**ADDENDUM NO. FOUR (4)
VILLAGE CREEK STATE PARK
HARDIN COUNTY, TEXAS
PROJECT NO. 128695
FACILITY DAMAGE REPAIRS**

Revisions to Drawings:

**VILLAGE CREEK STATE PARK
 FACILITY DAMAGE REPAIRS
 PROJECT NUMBER: 126695**

SHEET NUMBER
M3.1
 25 OF 30

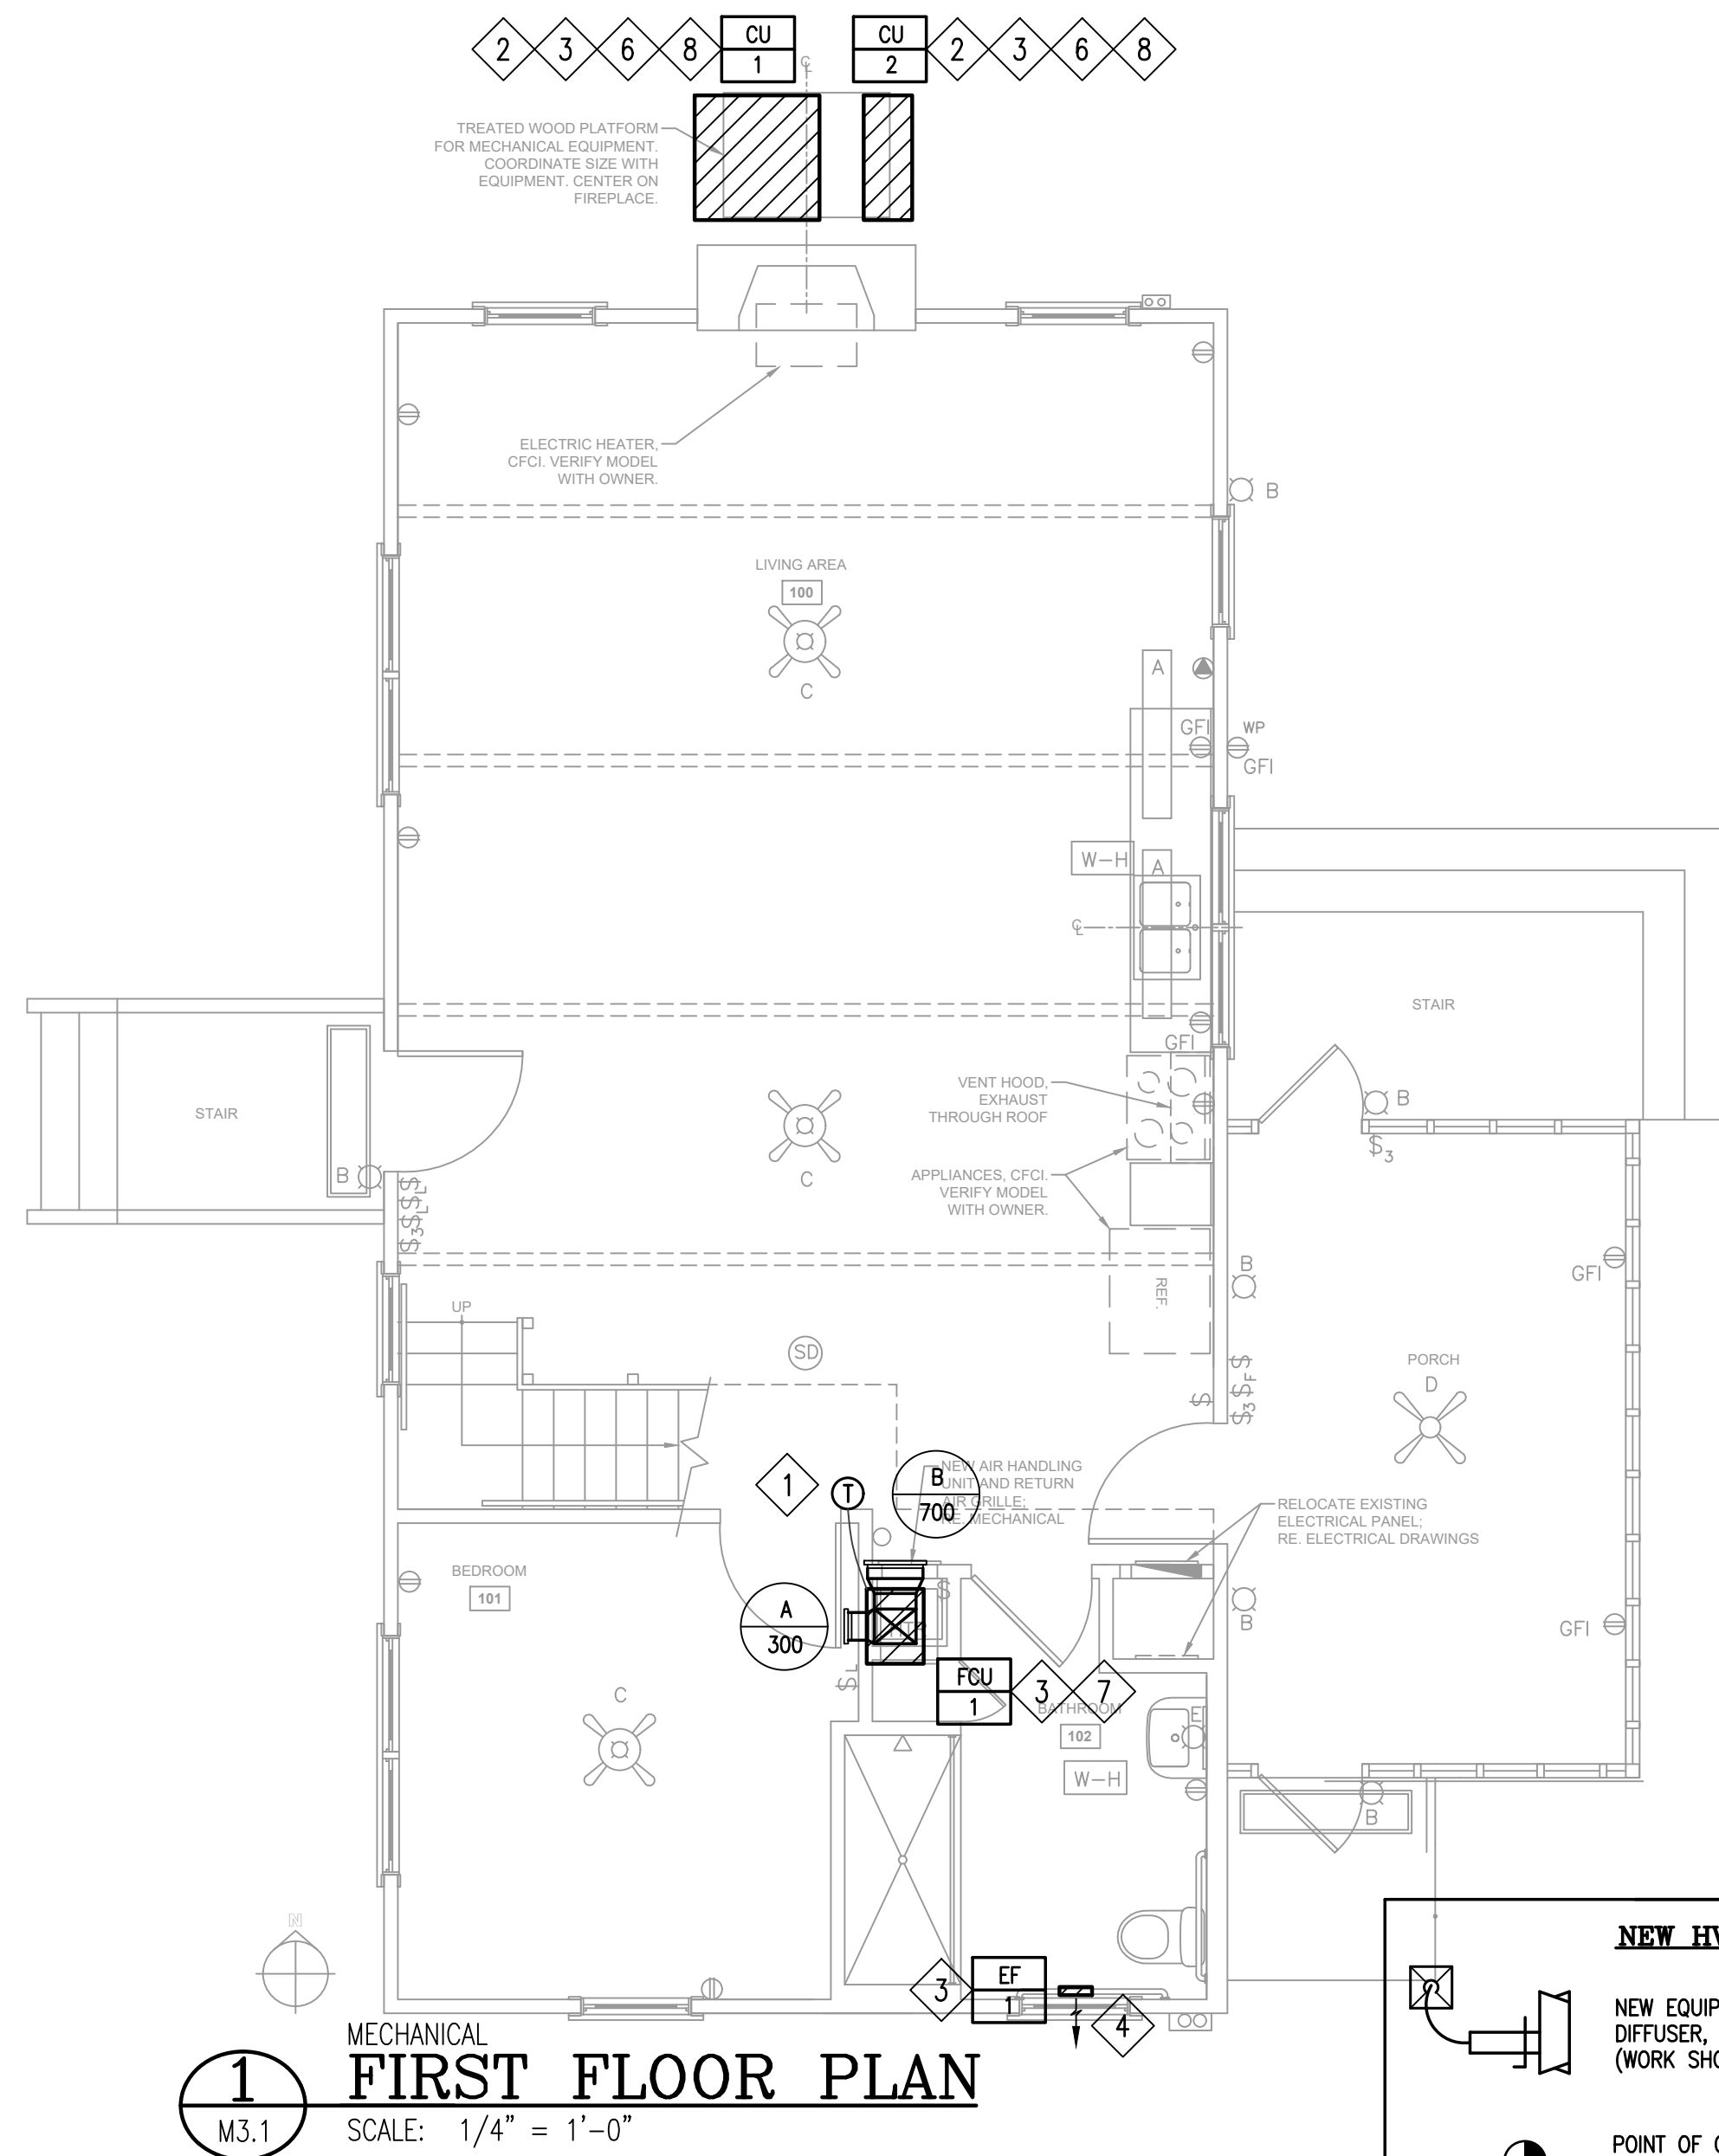
4. The HVAC system they have specified isn't what is in the building they have an apartment style wall mounted air handler in there currently and not enough room to install the specified air handler they are asking for I am looking into which exact matchup will make the required Seer rating. Please advise

5. Mini split (Dt12 /Sheet M3.1) is shown on north wall. This is an open railing area – will this require a wall to hide the unit? How about relocating the mini split on the north wall?

ANSWER: - Reference updated Mechanical Drawings for new Condenser unit and SEER Requirements.

ANSWER: Reference updated Mechanical Drawings for relocation of mini split system.

- KEYED NOTES**
- 1 CONTRACTOR TO MOUNT THERMOSTAT ON NORTH WALL RAIL. PROVIDE BUILD OUT AS REQUIRED.
 - 2 INSTALL CONDENSING UNIT PER MANUFACTURER'S SPECIFICATIONS AND MAINTAIN ALL RECOMMENDED CLEARANCES.
 - 3 INSTALL MECHANICAL EQUIPMENT PER MANUFACTURER'S SPECIFICATIONS AND MAINTAIN ALL RECOMMENDED CLEARANCES.
 - 4 FINISH OUTSIDE FACE OF FAN PER THE MANUFACTURERS RECOMMENDATIONS.
 - 5 BALANCE OUTSIDE AIR DAMPER TO 20 CFM.
 - 6 INSTALL CONDENSING UNIT ON SP-NRE PADS.
 - 7 ROUTE CONDENSATE LINE TO SANITARY DRAIN BELOW FLOOR.
 - 8 CONTRACTOR TO MOUNT CONDENSING UNIT ON 6' TALL HVAC EQUIPMENT STAND. LOCATE TO MINIMIZE VISUAL IMPACT.
